Operator: BONANZA CREEK ENERGY OPERATING COMPANY LLC

Location Name: ANTELOPE 42-19 RTB

Inspection: 696306479

Exhibit A

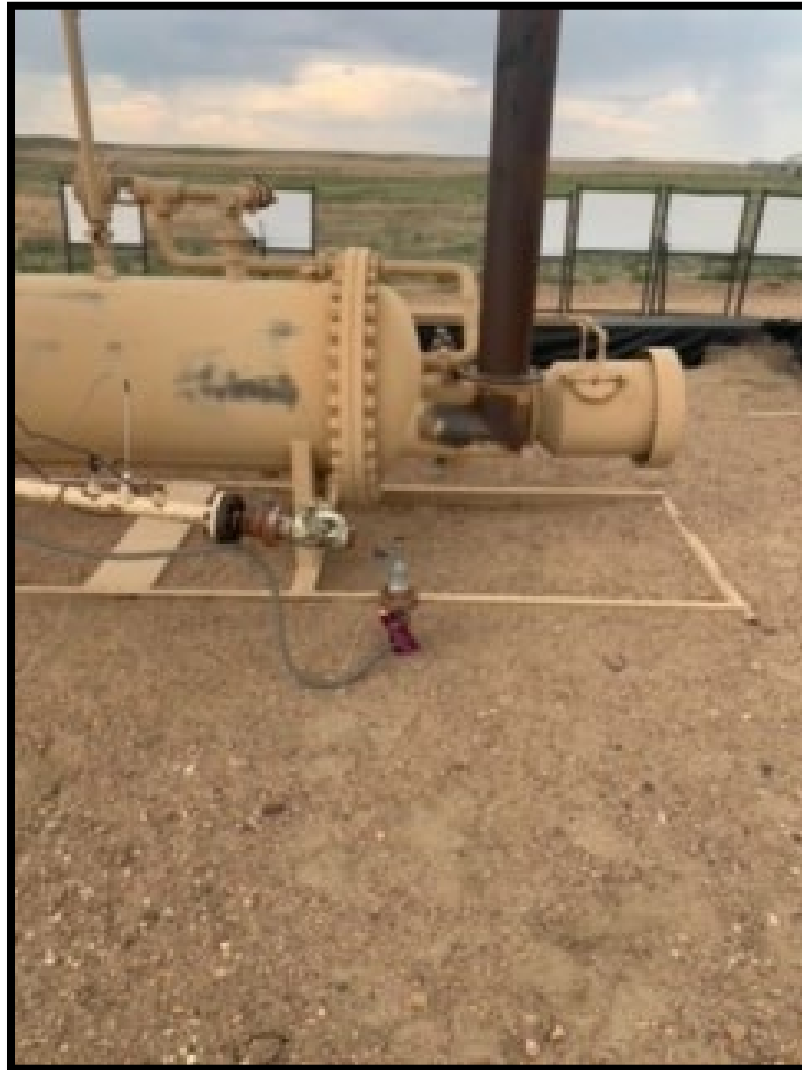
CA: Unmarked Risers at Separators; see photos. Upon removing a flowline or crude oil transfer line from use with the intent to abandon, an operator must immediately apply OOSLAT to the risers. OOSLAT must stay in place at all times during the process of abandoning the flowline or crude oil transfer line until the operator removes the riser. Comply with Rule 1105.b.

CA Resolution: Operator has reported that identified risers have been appropriately marked to comply with Rule 1105.b.
